**DCE MEMORANDUM 16-14**  
*(FHWA Approved: 7/21/2014)*

**SUBJECT:** CORRECTION TO DESIGN STANDARD, INDEX 11860, SHEET 4

| <p>LAST REVISION<br/>07/01/14</p> | <p>DESCRIPTION:<br/>Added Note #4 in the BRACKET DETAIL and Rearranged page for clarification.</p> |  <p>FDOT 2014<br/>DESIGN STANDARDS</p> | <p>SINGLE COLUMN GROUND SIGNS</p> | <p>INDEX NO.<br/>11860</p> | <p>SHEET NO.<br/>4 of 8</p> |

CONNECTION AND WIND BEAM

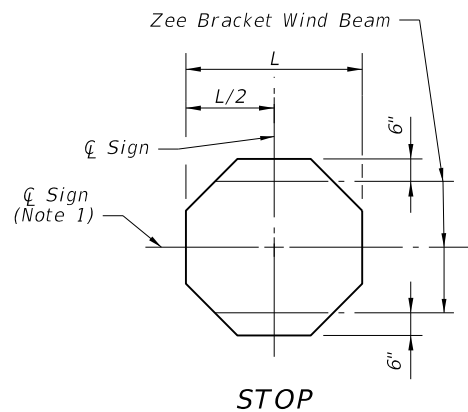
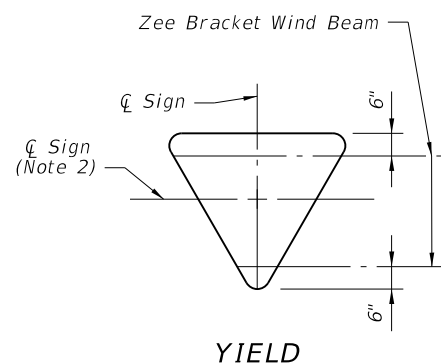
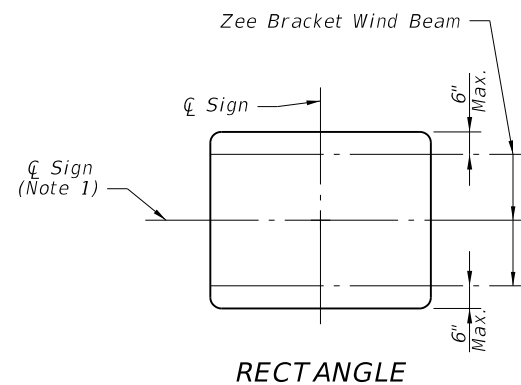
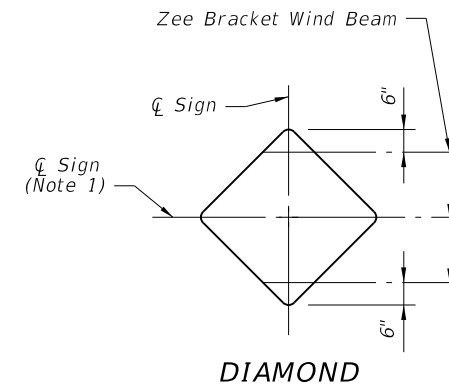
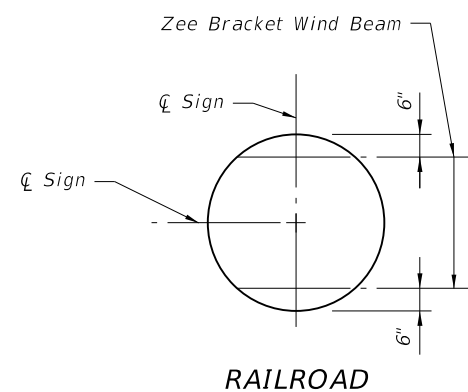
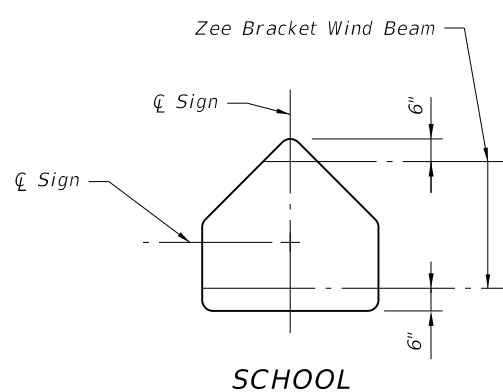
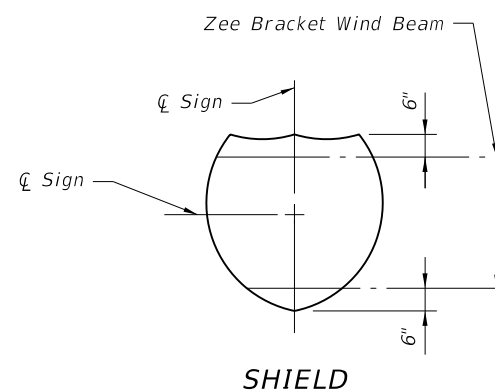
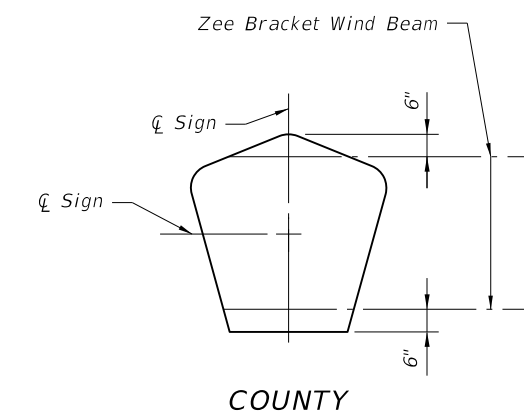
The current Design Standards, Index 11860, Sheet 4, requires a third zee bracket when either dimension of the sign panel is greater than 30". Attached is revised Design Standard, Index 11860, Sheet 4 that modifies this language and only requires a third zee bracket when the sign height is greater than 30".

For projects impacted by this correction, replace Index 11860, Sheet 4 with the attached Design Standard revision. This memorandum serves as a blanket approval to process a \$0.00 contract change and should be attached to the Work Order or Supplemental Agreement.

1. For signs with heights greater than 30" a third zee bracket wind beam shall be installed along the centerline.
2. For Yield signs greater than 36" a third zee bracket wind beam shall be installed along the centerline.
3. Use only one Wind Beam at centerline for sign height up to 12".
